From: Detlef Knappe [knappe@ncsu.edu]
Sent: 3/2/2017 1:04:18 PM
To: Sun, Mei [msun8@uncc.edu]; Strynar, Mark [/o=ExchangeLabs/ou=Exchange Administrative Group (FYDIBOHF23SPDLT)/cn=Recipients/cn=5a9910d5b38e471497bd875fd329a20a-Strynar, Mark]
CC: Lindstrom, Andrew [/o=ExchangeLabs/ou=Exchange Administrative Group (FYDIBOHF23SPDLT)/cn=Recipients/cn=04bf7cf26aa44ce29763fbc1c1b2338e-Lindstrom, Andrew]
Subject: Re: FW: Chemical Structures

I am the corresponding author of the paper "Legacy and Emerging Perfluoroalkyl Substances Are Important Drinking Water Contaminants in the Cape Fear River Watershed of North Carolina" published in Env. Sci. & Tech. Letters 2016 3 (12) 415 (DOI: 10.1021/acs.estlett.6b00398). The authors were recently contacted about two of the molecular structures we are showing in the supporting information of the paper. The suggestion was made that the two chemicals are more likely branched instead of linear as follows:

Legacy and Emerging Perfluoroalkyl Substances Are Important

Chemical	Structure shown in current IS	Should be changed to
PFMOPrA

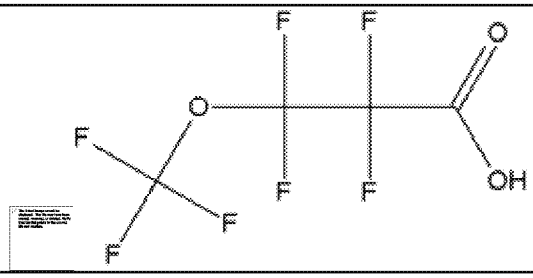
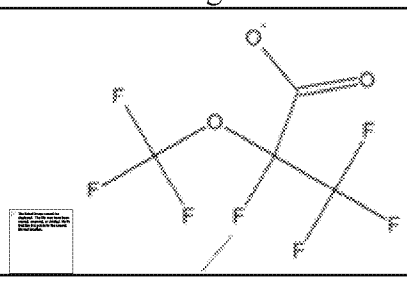
I believe that the structural assignments for PFMOBA [$CF_3OCF_2CF_2CF_2COOH$] and PFMOPrA [$CF_3OCF_2CF_2COOH$] are most likely incorrect.

More reasonably the correct structures are isomers $CF_3CF_2OCF(CF_3)COOH$ and $CF_3OCF(CF_3)COOH$ respectively. I doubt that the MS/MS could tell the isomers apart.

I made a few wording changes below. Also, it would be better to show the protonated forms, like we did in the original paper so that the molecular weights match the structures.

After a review of our high resolution mass spectrometry results, we concur that the branched structures are more likely.

In our paper Strynar et al., 2015 we proposed these structures as below: (Figure S7). These are the ones Paul suggests are more likely.

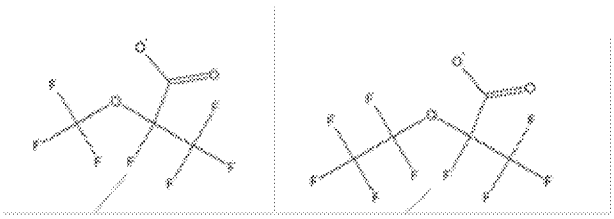
The QTOF can distinguish between the two as the likely breaking point is at the ether oxygen. We would get different fragments for the PFMOBA, not the PFMOPrA.
